**STAFF REPORT 04-13-2021 REGULAR MEETING**

**APPLICATION NUMBER: 21-7744**

**ADDRESS: 603 E MILWAUKEE (AKA PEERLESS BUILDING)**

**SCOPE: REPLACE WINDOWS**

*Detail view of steel sash windows and concrete sill/brick at first floor. Staff photo, November 2, 2021*

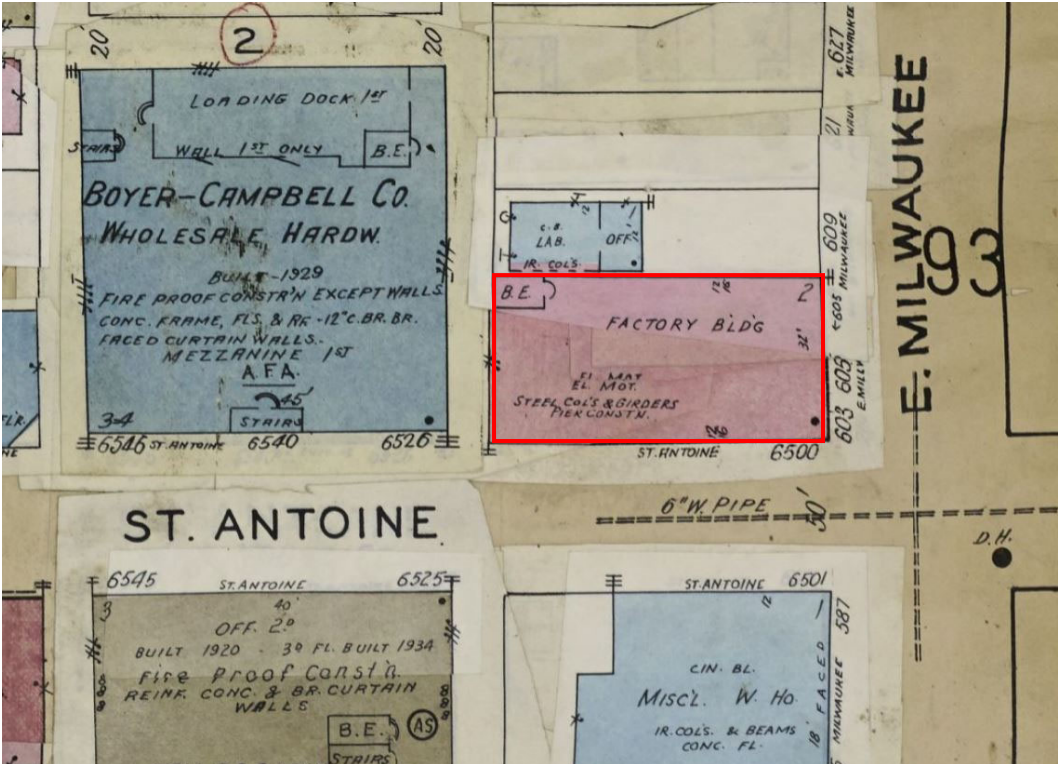
- **Steel sash windows:**
- We have now received, via this new application, a quote for repair of the windows.
- The report characterizes the windows as being in “very poor” condition. Staff disagrees and would characterize them as poor to fair. These are industrial windows built for an industrial use, and should not be held to an appearance or performance standard for windows that may be desirable for a modern luxury residences. There are areas of substantial decay, but repair is feasible.

- The remaining steel windows at the primary elevation on St. Antoine (staff counts ten, including one opening partially replaced with new) are distinctive character-defining features that define and establish the historic character of this property.

- In staff opinion, the remaining steel sash and wood windows at the two primary elevations (i.e., along St. Antoine and East Milwaukee) can and should be retained for the proposal to qualify for a COA

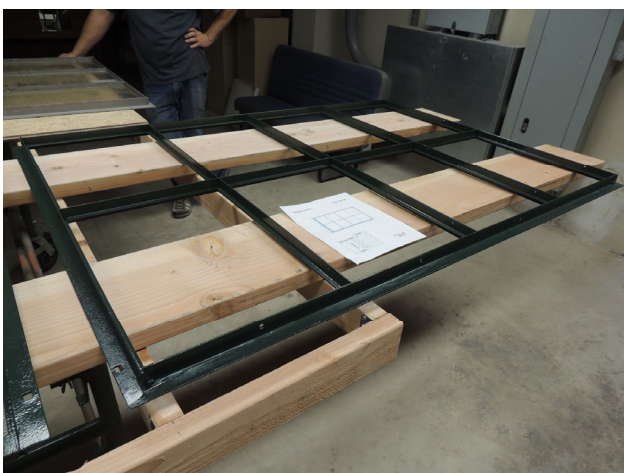
- Staff has included in this report photographs from an unrelated project, with your staff writer as the consulting historic architect, for a historic rehabilitation project for a National Park Service property on the east coast, which featured steel industrial windows in very poor condition. The windows were restored and reinstalled.
